# **FIRE SAFETY INSPECTION REPORT**

**SHARMIN FASHIONS LIMITED**  
**EAST NARASHINGHAPUR, ZIRABO, ASHULIA, SAVAR**

**ACCORD**  
on Fire and Building Safety in Bangladesh

April 23, 2014

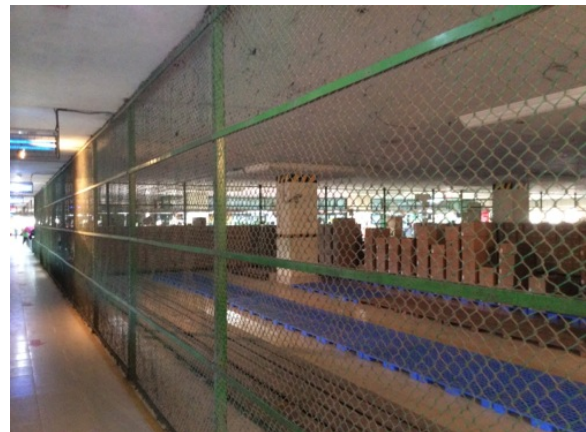
No.	Category	Finding	Recommendation	Remediation Timeframe
F-1	Fire Rated Construction	Hazardous materials / flammable liquid storage areas are not separated by fire-rated construction (openings, non-rated doors, penetrations).  Locations: -55 gallon drums of diesel fuel located adjacent to generators. -Possible hazardous area on First floor where masked personnel was spraying unknown substance in an unsealed, non-ventilated area.	Separate the hazardous materials / flammable liquid storage room by a minimum 2-hr fire-rated construction. Seal and/or protected all openings to maintain the required fire separations.	Within 3 months

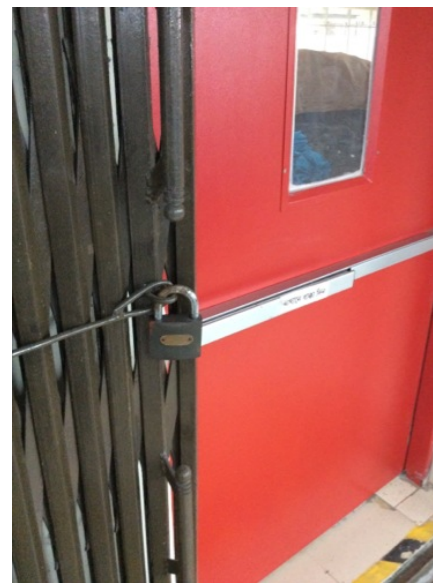
F-7	Egress	Egress doors / gates with locking features are provided at building exits, exit stairs, along egress routes, and exit discharge.  Locations: All floors.	Remove locking features from all egress doors / gates.  If locks are required for security reasons, utilize special door locking features complying with NFPA 101.	Immediate
-----	--------	---	--	-----------
